PRELIMINARY CONSULT: Donna Holverson
rear Addition, swimming pool and tree
removal - 35 West Lenox St. (CCVHD)

HISTORIC PRESERVATION COMMISSION STAFF REPORT

Address: 35 West Lenox Street, Chevy Chase	Meeting Date: 07/14/99
Resource: Chevy Chase Village Historic District	Report Date: 07/07/99
Case Number: Not applicable	Public Notice: 06/30/99
Review: Preliminary Consultation	Tax Credit: None
Applicant: Donna Holverson	Staff: Perry Kephart

PROPOSAL: Swimming Pool, Tree Removal, Rear Addition

Tree Removal - 1-18" Hickory

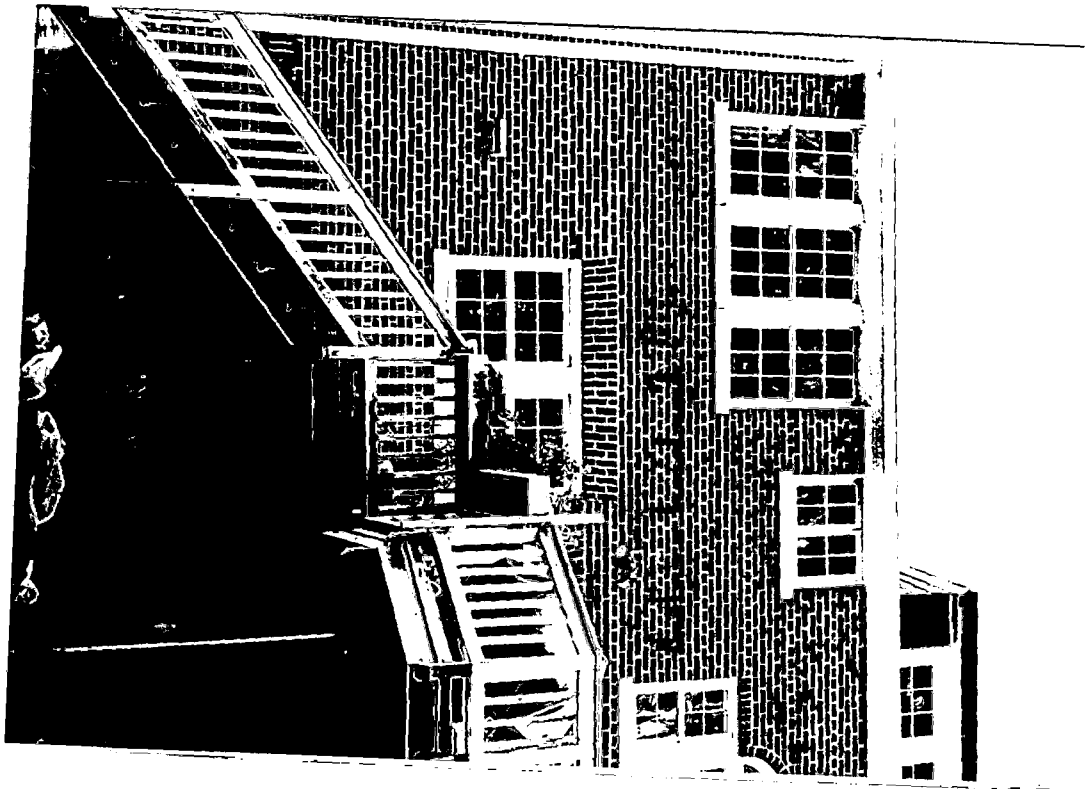
Very Threatened - but

trying to save.

SITE PLAN
SCALE 1"=10'-0"

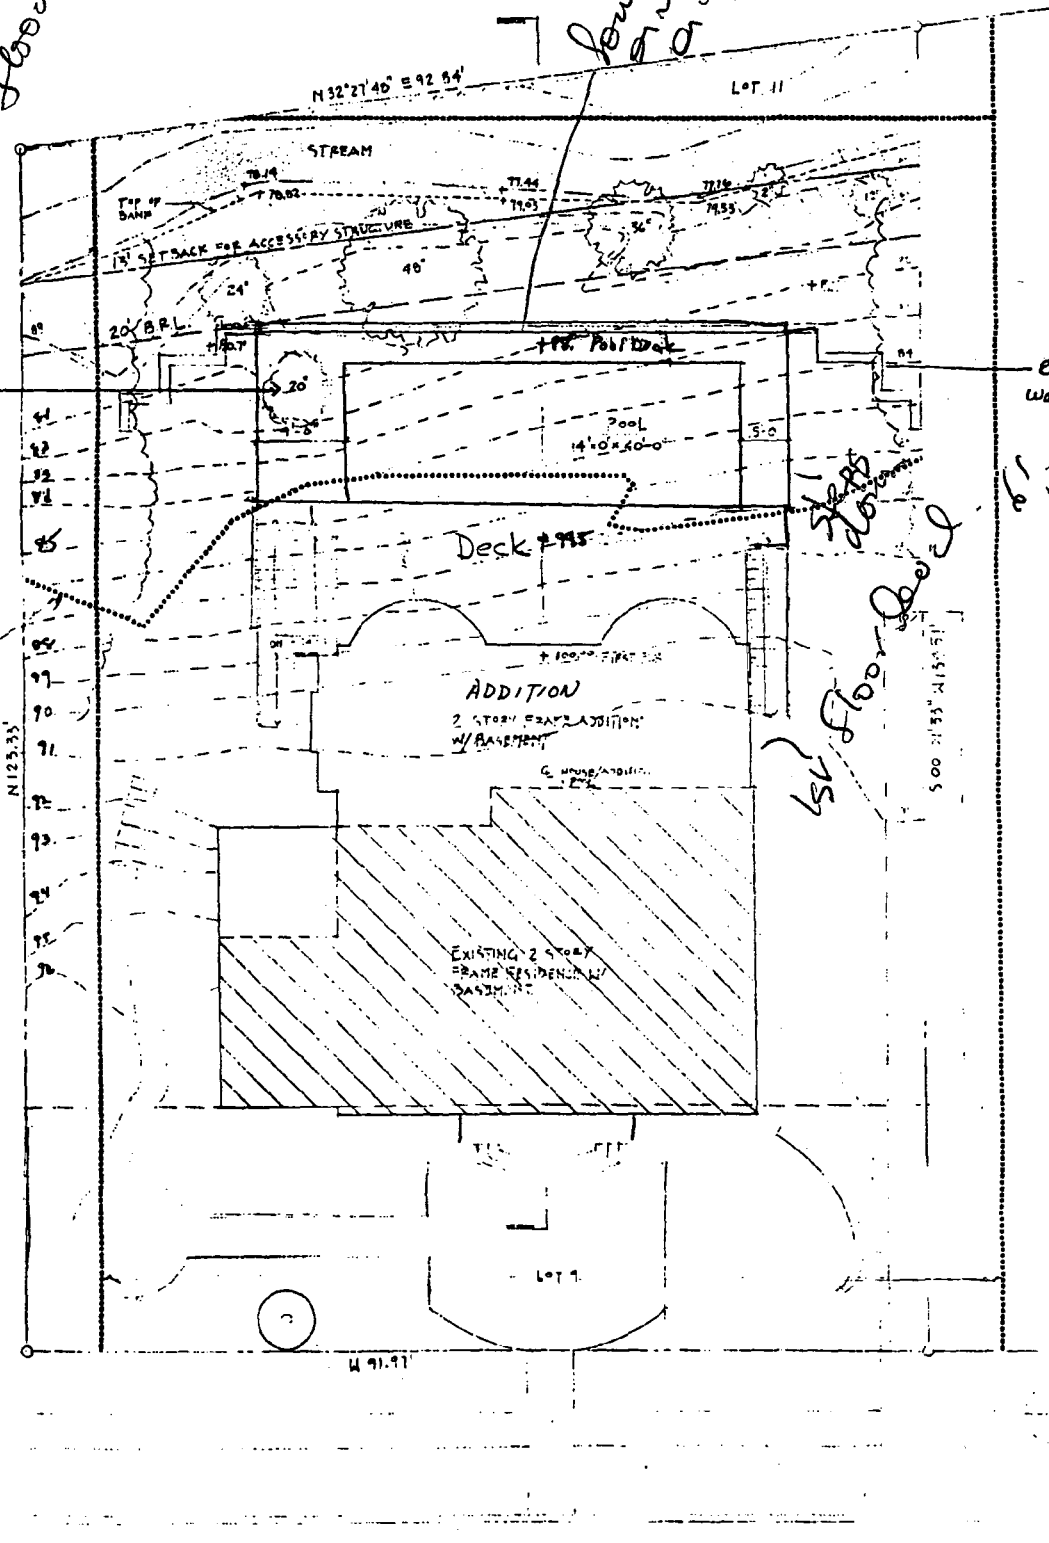
*where BR-2548
flood plain is
700 yds*

*foundation
of retaining wall
is steel beam*

*It more
concern w/
design of addition*

*retaining
wall
6'-8"
height*

*steps
down
1st floor level*
